**MIDDLETON CITY PLANNING AND ZONING
COMMISSION MINUTES
AUGUST 8, 2022**

PRELIMINARY PLAT FOR HIDDEN MILL SUBDIVISION

City Engineer & Planner Comments

RE: **Hidden Mill Subdivision –Preliminary Plat**

**PRELIMINARY
PLAT**

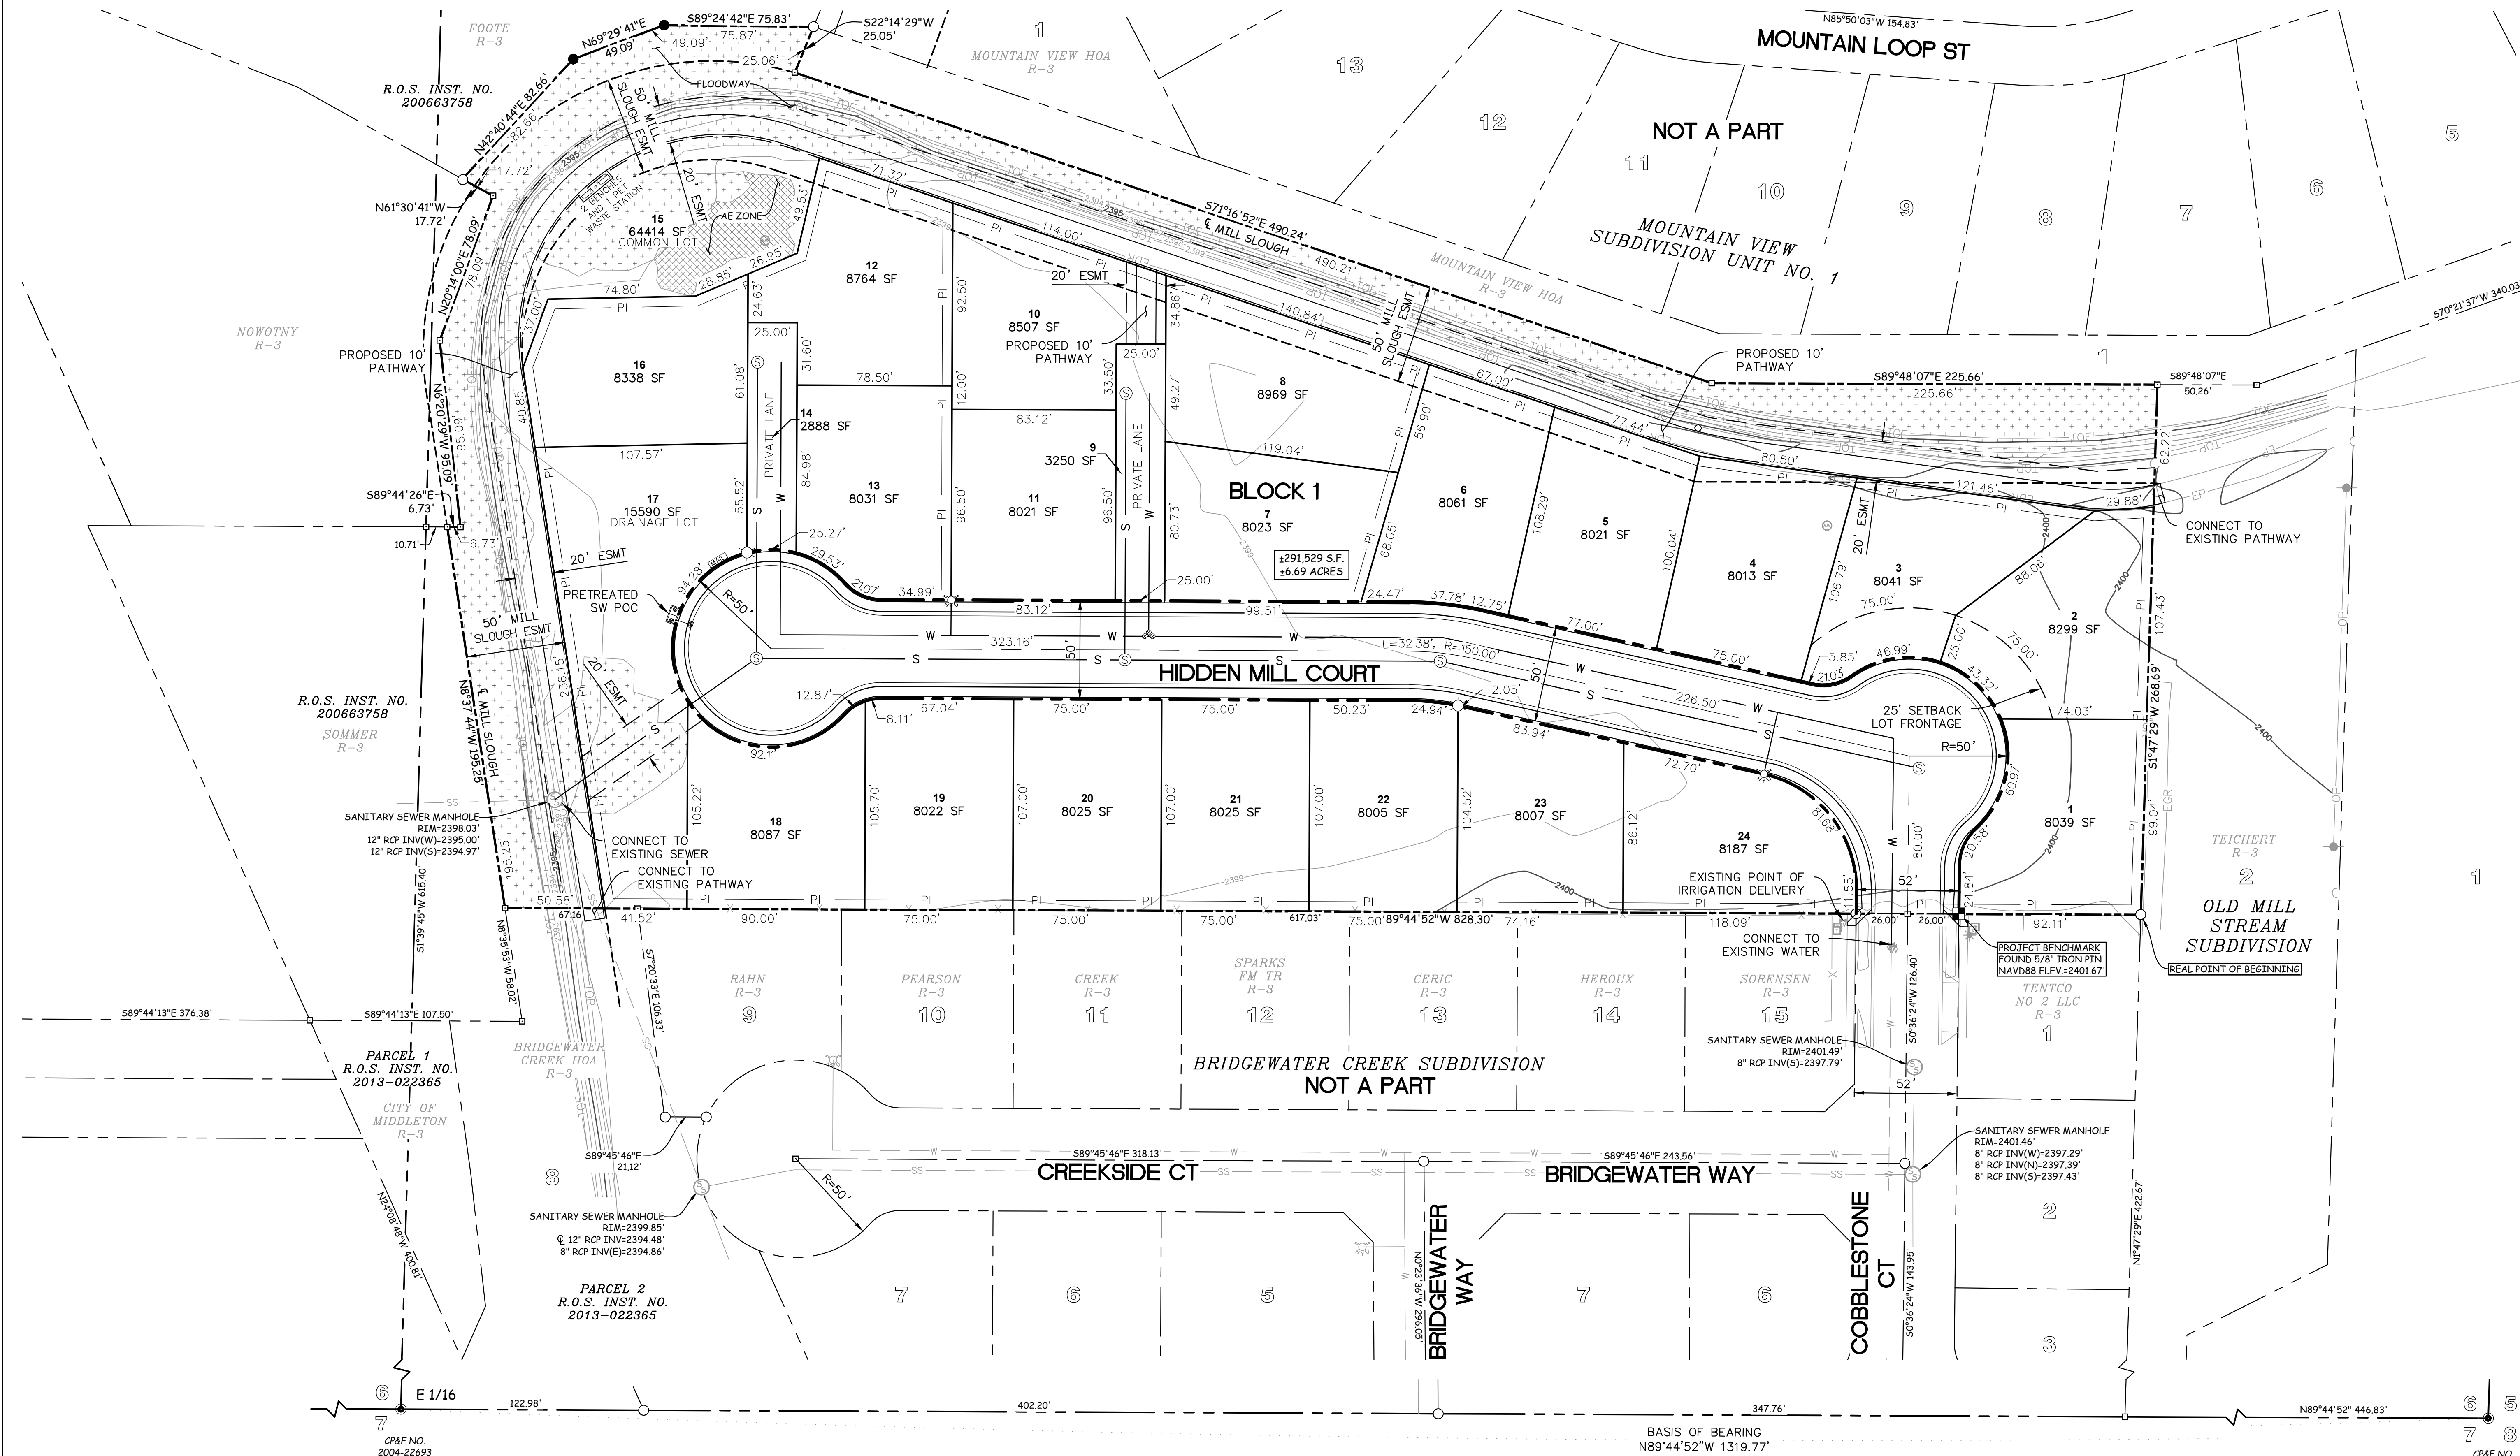
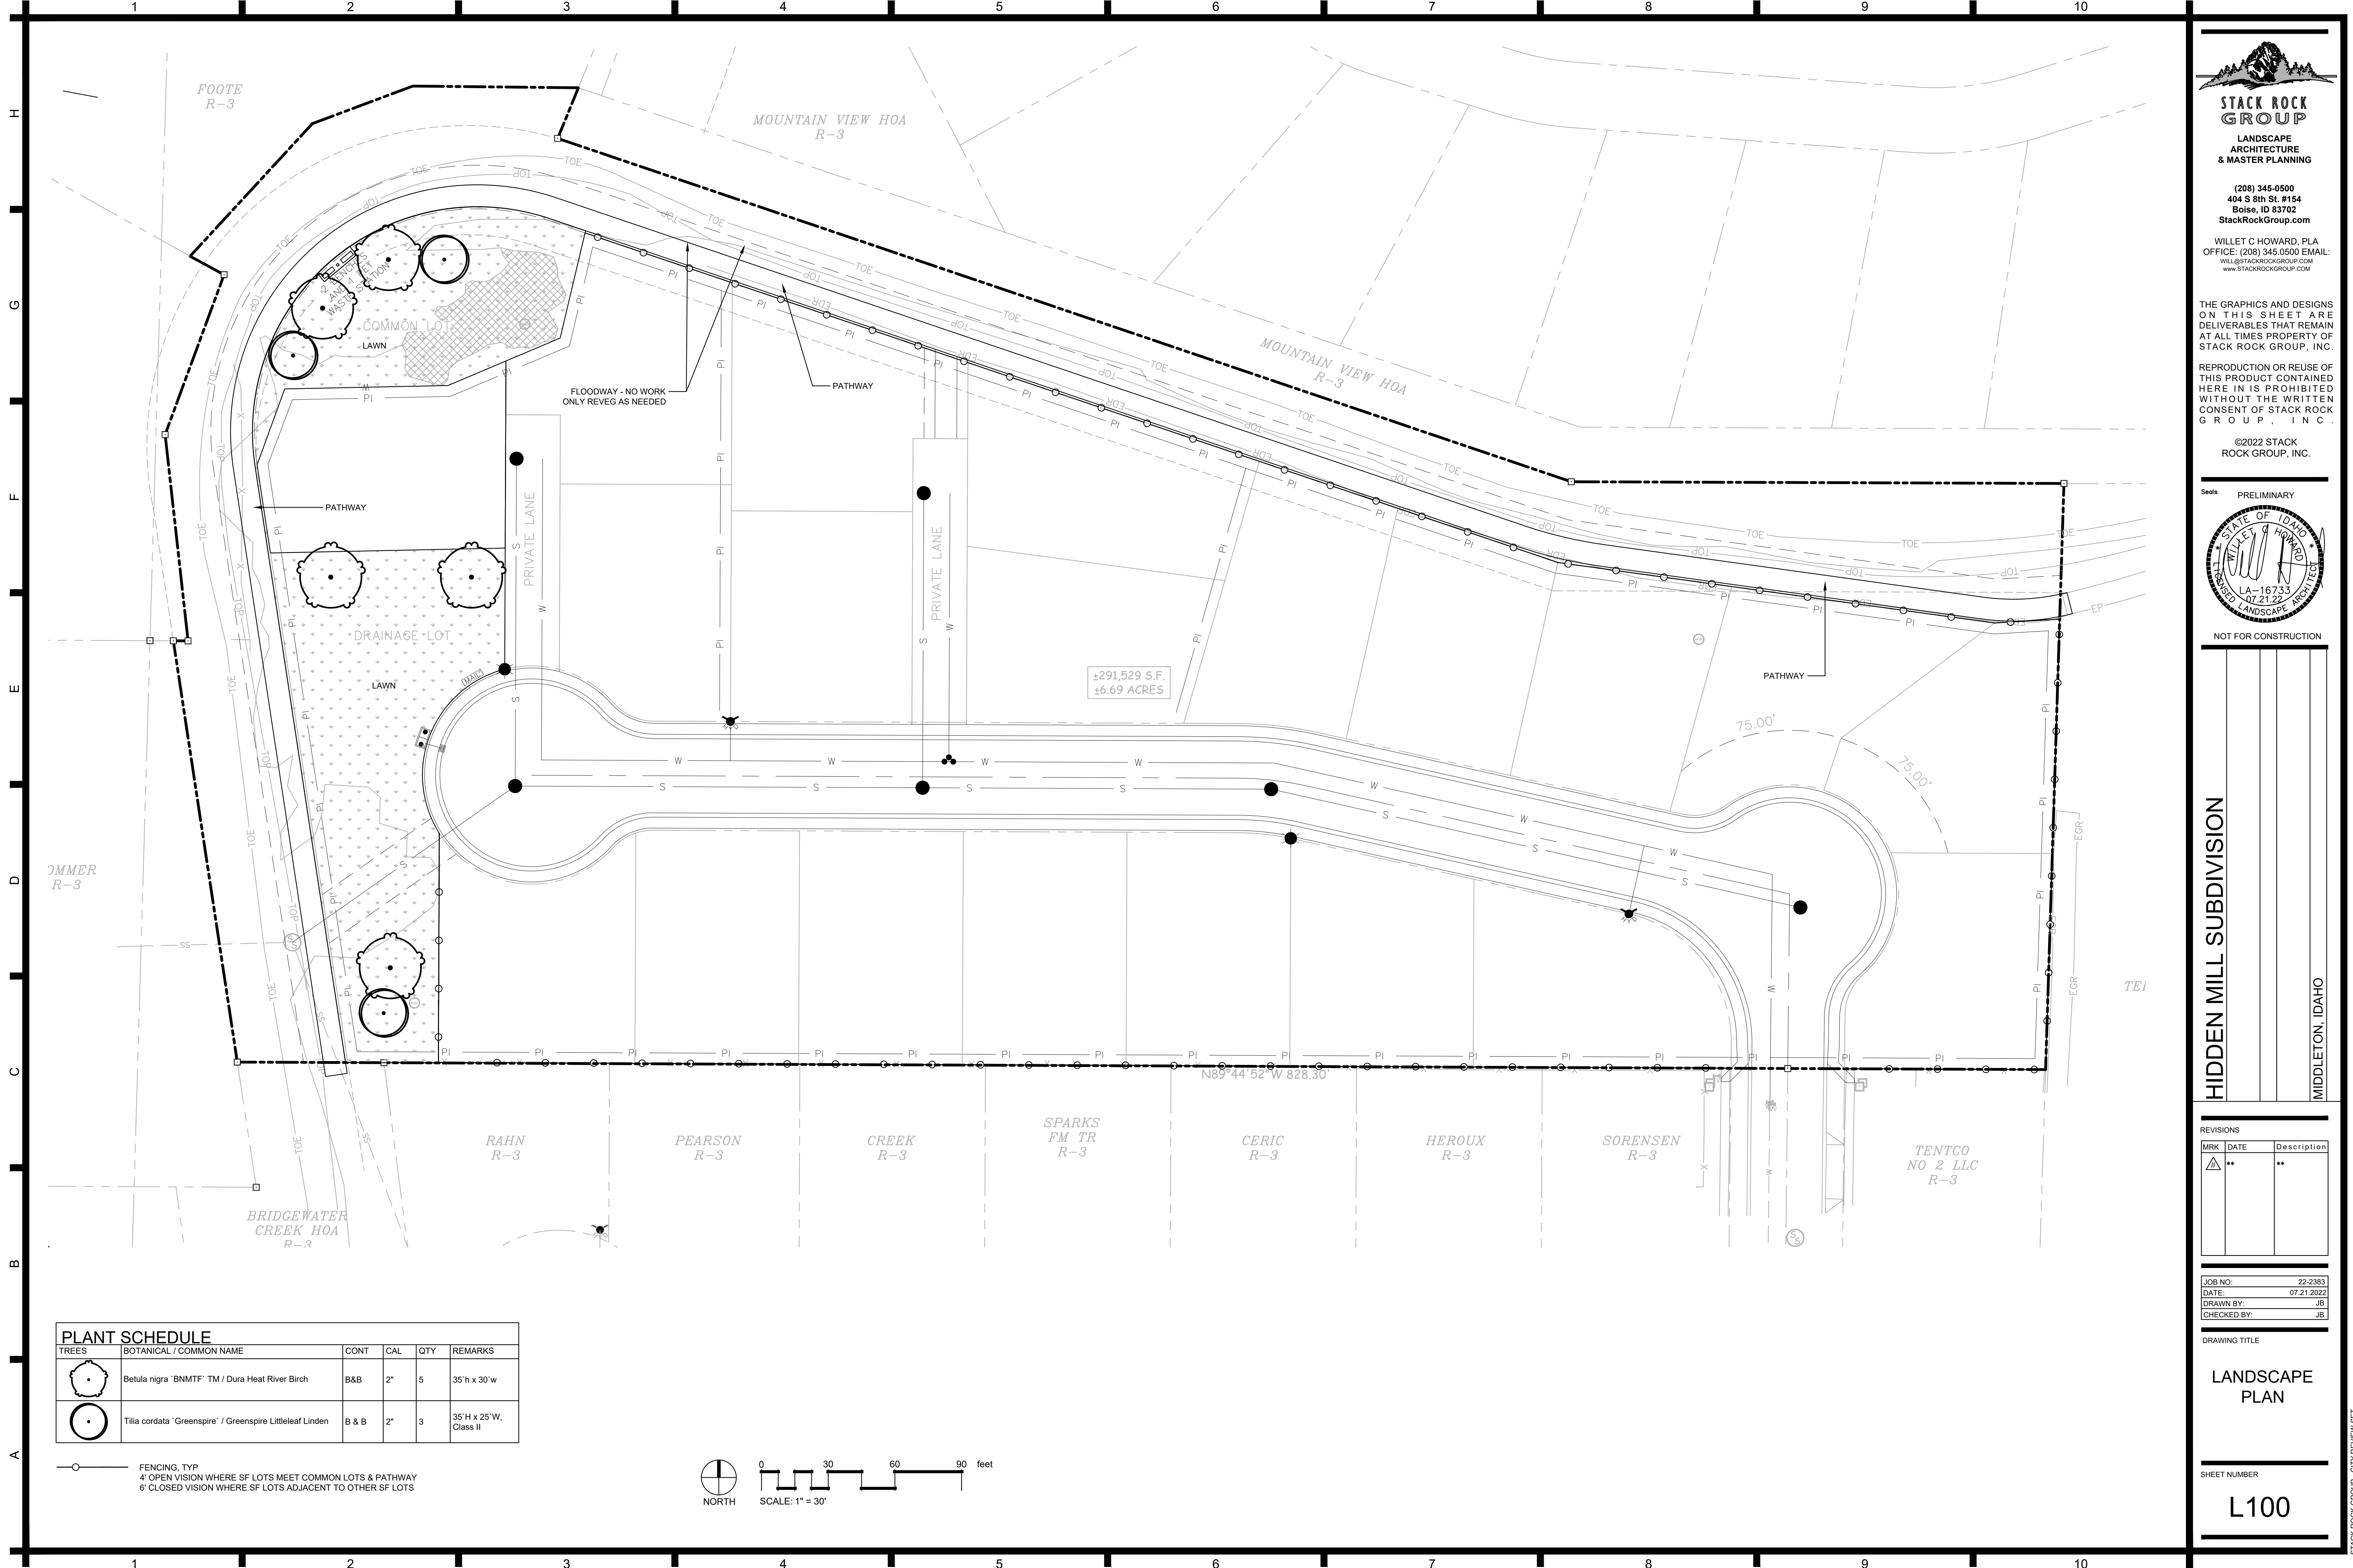
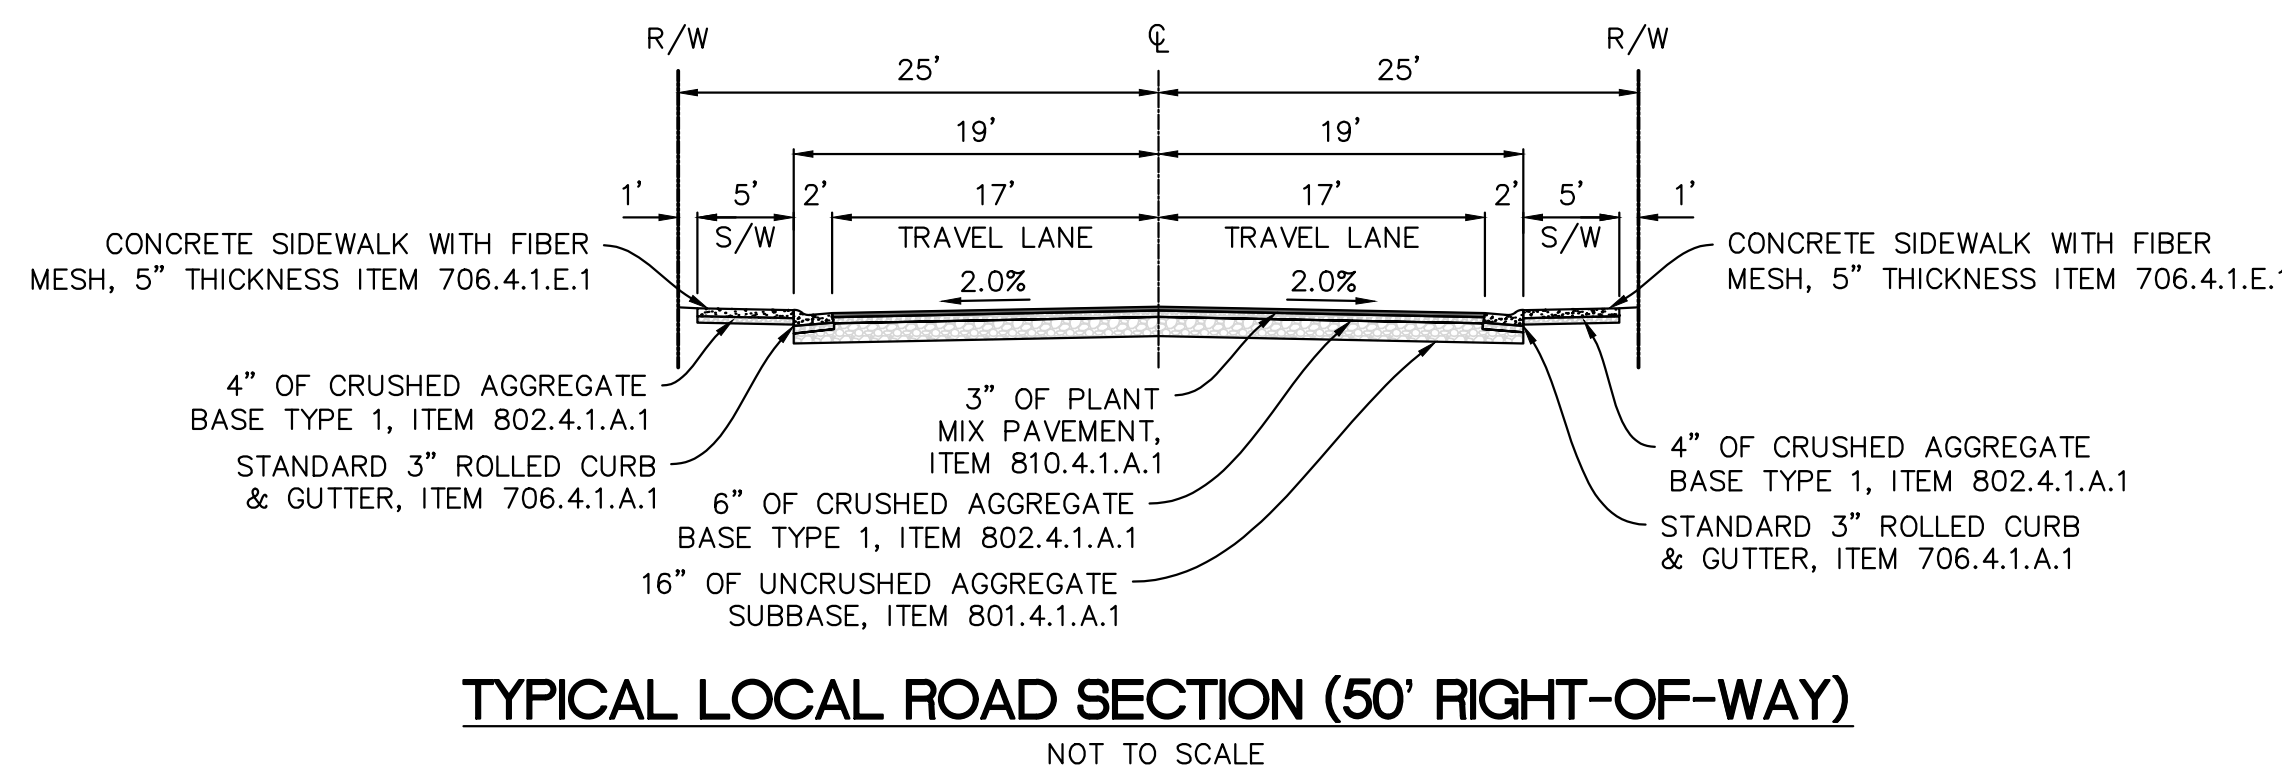
Reduce plat to one page.

MCC 5-4-4.2. a. Please add bearing and distance to section corner, quarter corner or monument of record.

MCC 5-4-4.2. b. Add title block to the upper center. Add location and date.

MCC 5-4-4.2. g. Show floodplain and floodway on the plat.

1. Dimension rights of way.
2. Show existing easements for Mill Slough.

MCC 5-4-4.2 a and l. The boundary is required to be surveyed and stamped by PLS including ties to corners. Use the description you provided and verify the boundary can be retraced before you resubmit.

A MCC 5-4-10-2. o. Number lots sequentially. Is Mill Slough area going to be a separate lot?

1. There is not sufficient sewer depth as shown. There is less than one (1) foot of cover. Add a note regarding site fill or otherwise address. Less than 3ft of cover is a concern for the City.

1. Add a note: Stormwater facilities are owned by HOA and the provisions for maintenance will be specified in CCRs. Specify lot 14 as used for stormwater management.

Note 6. Combine note 6 and note 12. Identify irrigation district and whether lots are subject to assessment.

Note 1. Put "and" between general access and utility.

Submit a variance application if the cul-de-sac length is greater than 600ft. Dimension it please – so the length may be verified.

MCC 5-4-4.2. g. Show floodplain and floodway on the plat. This information is not discernable.

1. Dimension rights of way. Keep the 52ft right of way for Cobblestone through the culdesac then transition to 50ft for Hidden Mill limits.
2. Show existing easements for Mill Slough. If the Mill Slough easement is consistent through the limits then modify language to reflect 50ft from centerline of Mill Slough.

MCC 5-4-4.2 a and l. The boundary has a bearing in error on west side. Add the section corner and ties to PP-02.

1. There is not sufficient sewer depth as shown. There is less than one (1) foot of cover. **Add a note regarding the sewer and site fill: Up to three feet of site fill will be required for sewer installation.**

- SANITARY SEWER COLLECTION SHALL BE PROVIDED BY THE CITY OF MIDDLETON. UP TO 3FT OF SITE FILL WILL BE REQUIRED FOR SEWER INSTALLATION.
